# UNITED STATES PATENT AND TRADEMARK OFFICE

## Office Action Summary

10/643,862

## **DETAILED ACTION**

Fig. 1a

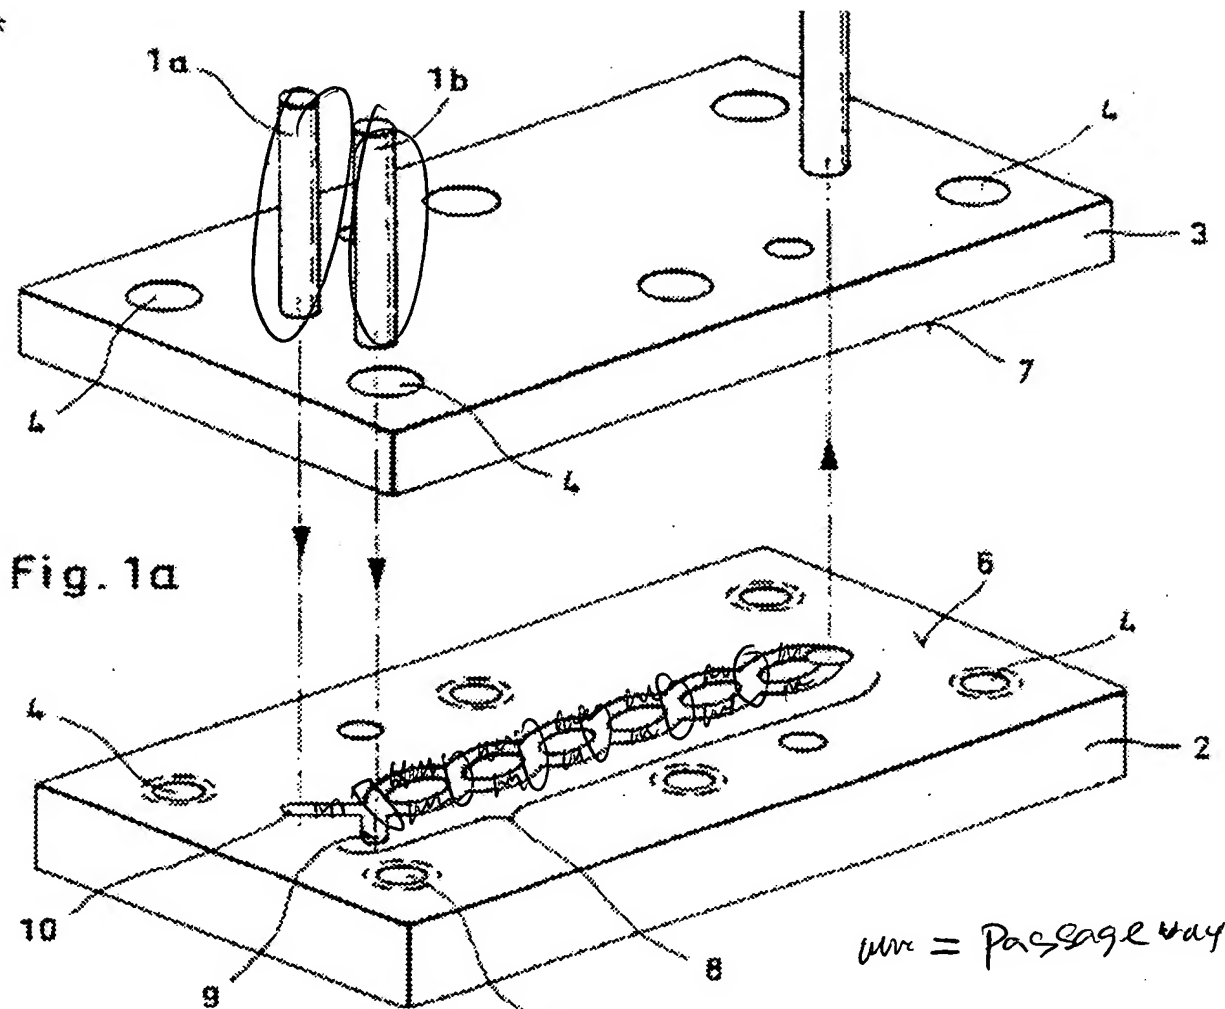
The Koop reference discloses an apparatus and method of use for mixing fluids including two inlets for a 1<sup>st</sup> and 2<sup>nd</sup> fluid to be fed into a 1<sup>st</sup> chamber at the intersection of 9,10, a second chamber through seventh at the intersection of the sinusoidal loops which are microchannel capillary passageways along the portion 8, see figure 1, which ends at an outlet chamber at 5 for further processing, whereby each loop side may be deemed as separated passageways.

MARKUP  
 TGS 1723

unc = passage way

O = chambers

9. Applicant argues that the Koop et al reference "containers no fist and second chambers connected through one or more separated capillary passageways" , see applicant's remarks page 10. In response, see the intervening chambers and connected passageways as discussed above in paragraph 4, and the figure mark up above.
